PLANT NAME:
Nine Mile Point Unit No. 1 (2-P)
RJL

Re: Niagara Mohawk Power Corporation
Nine Mile Point Nuclear Station
Unit No. 1--Docket No. 50-220

APPLICATION FOR AMENDMENT

Proposed Changes to Facility Operating License

FIGURE 1

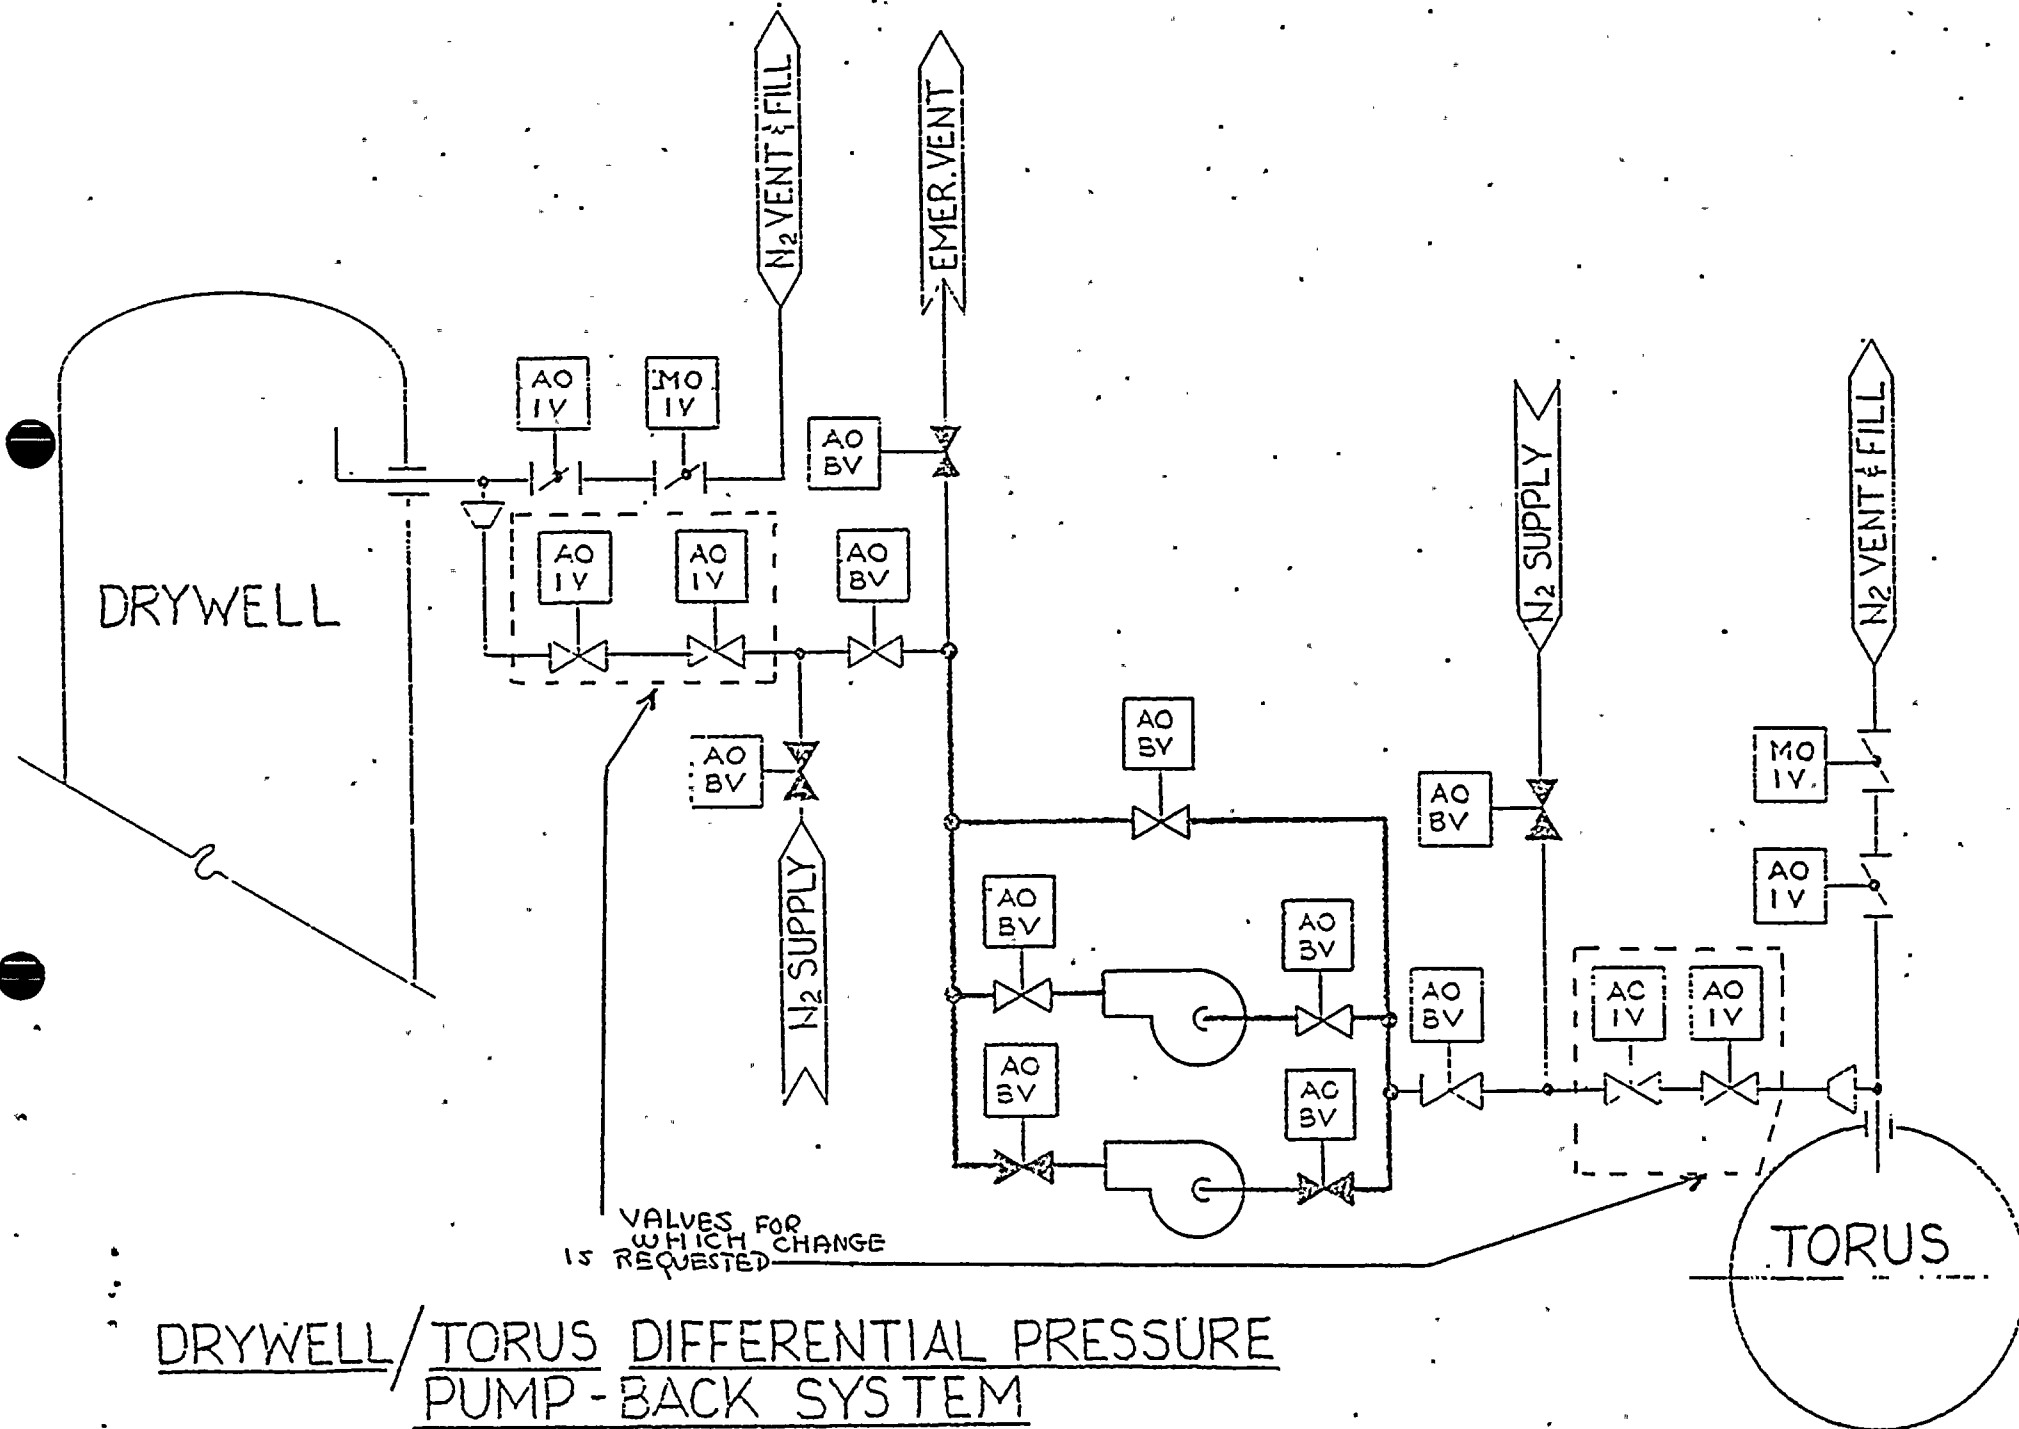
Presently, differential pressure is being maintained by a feed and bleed method. In order to maintain this differential pressure in a more efficient manor, a pump-back system is being installed at Nine Mile Point Unit 1. Figure 1 shows a sketch for this system. As shown, this system is connected downstream of the isolation valves on the Drywell N₂ Makeup and Suppression Chamber N₂ Makeup lines.

Operation of this system requires that isolation valves on the above lines must be open during operation. However, automatic closure of these valves on low-low reactor water level and high drywell pressure will assure that primary containment integrity is maintained.
